Western Digital Corporation
 20511 Lake Forest Drive
 Lake Forest, CA 92630

Subject: UAS Clause 6 (Usage)

This proposal defines the Usage clause for UAS. The Usage clause describes the communication sequences between the initiator and the target.

The following text replaces clause 6 of UAS.

Figure 2 — Non-data Transfer

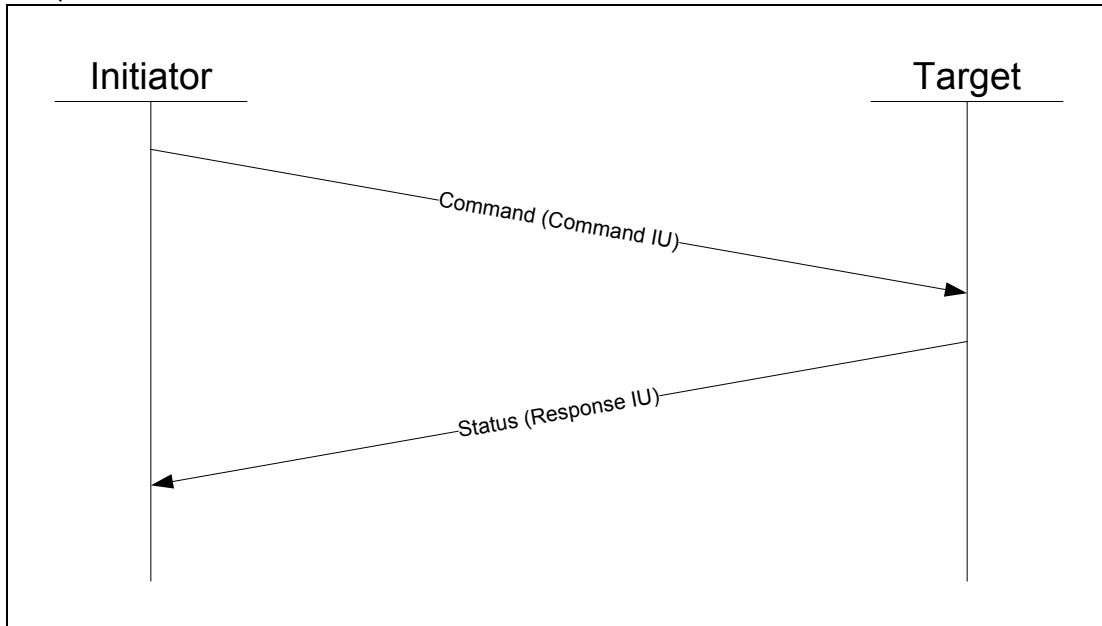
Figure 2 describes the sequence of communication between the initiator and target for a command which does not require data transfer.

Figure 3 — Write Data Transfer

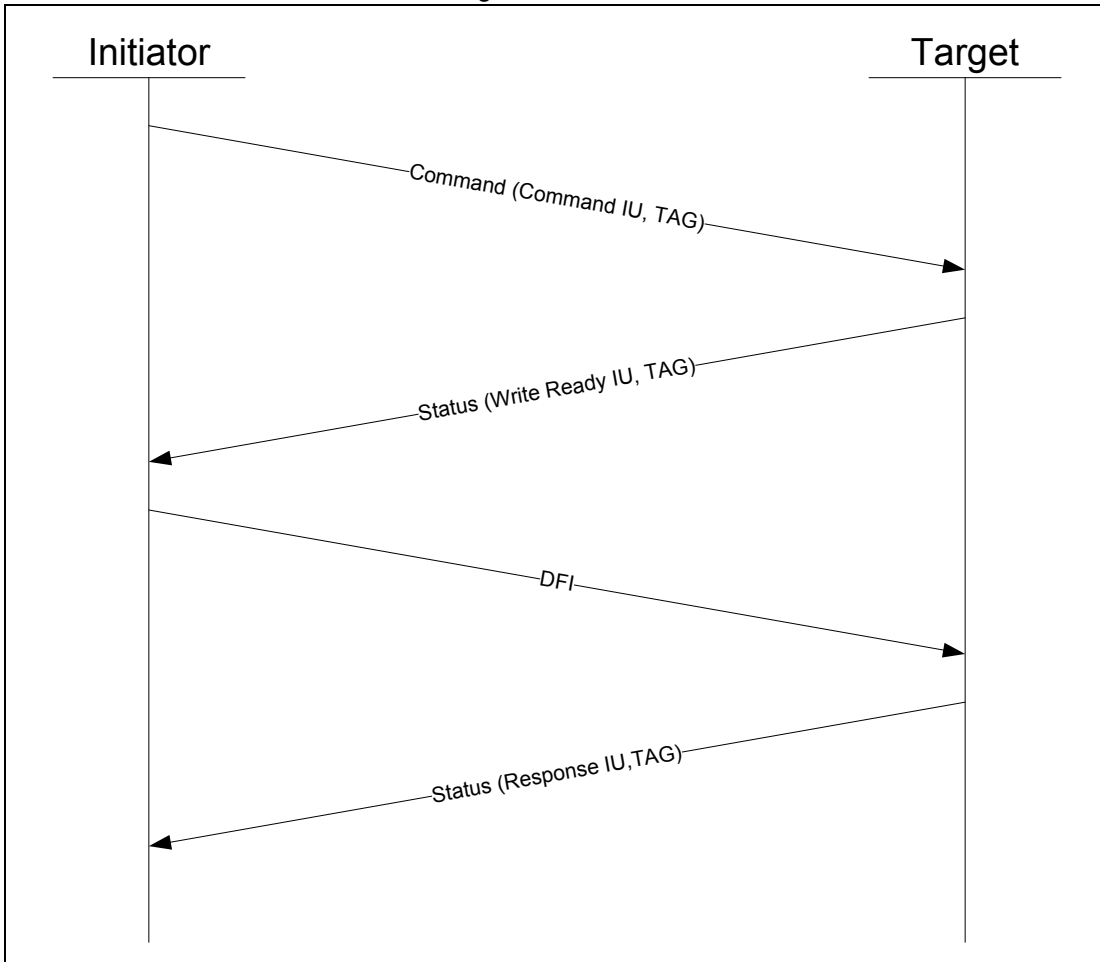
Figure 3 describes the sequence of communication between the initiator and target for a command which requires data transfer from the initiator to the target.

Figure 4 — Read Data Transfer

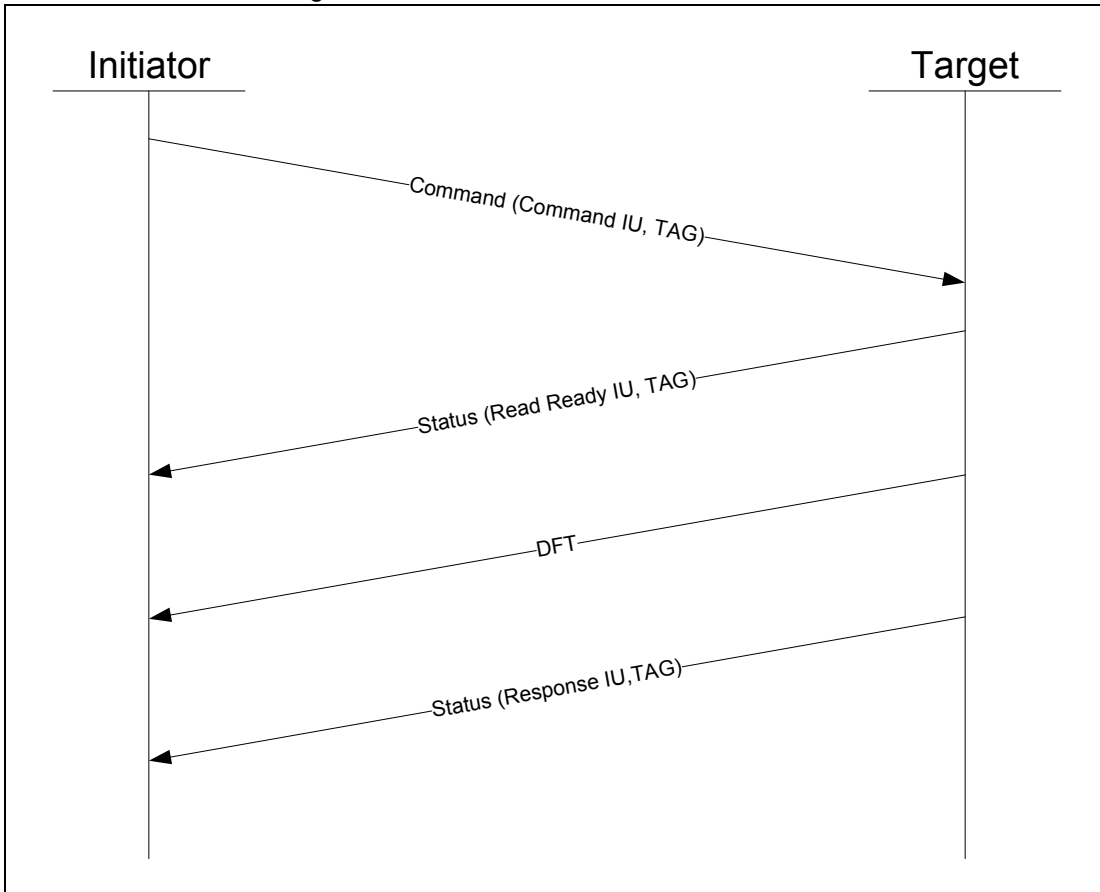
Figure 4 describes the sequence of communication between the initiator and target for a command which requires data transfer from the target to the initiator.

Figure 5 — Queued Example

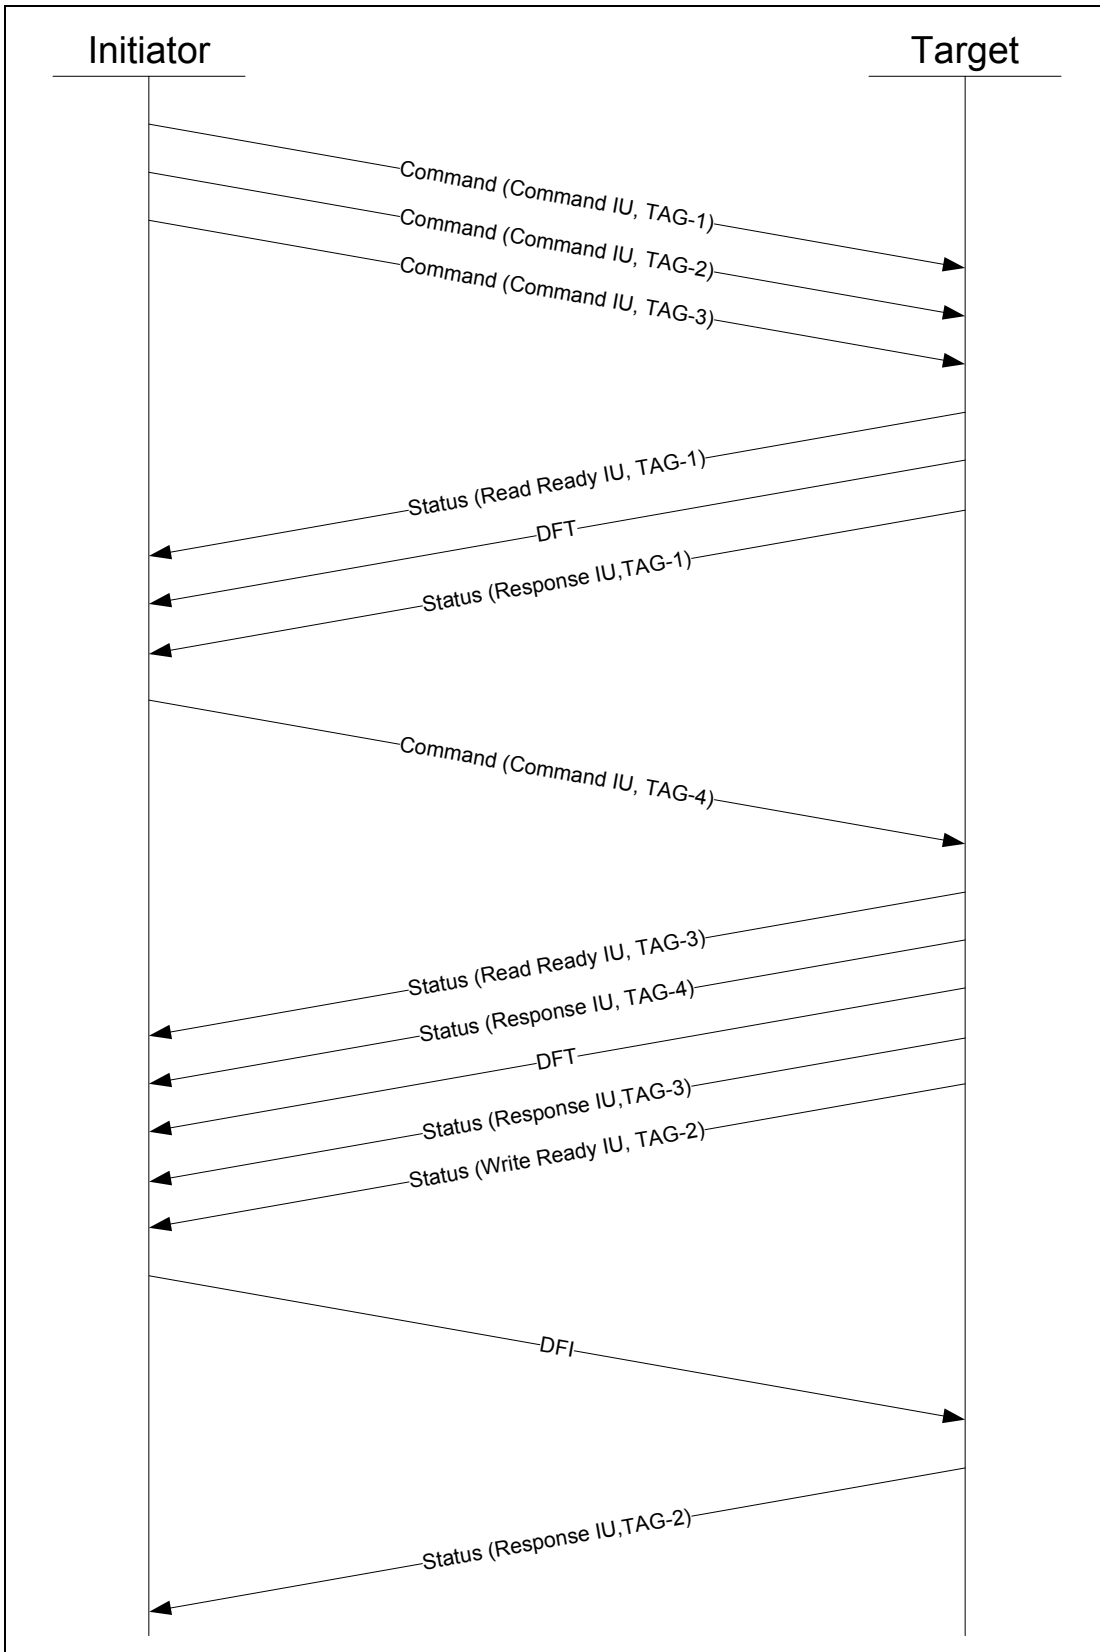
Figure 5 describes the sequence of communication between the initiator and target for a command which requires data transfer from the target to the initiator.
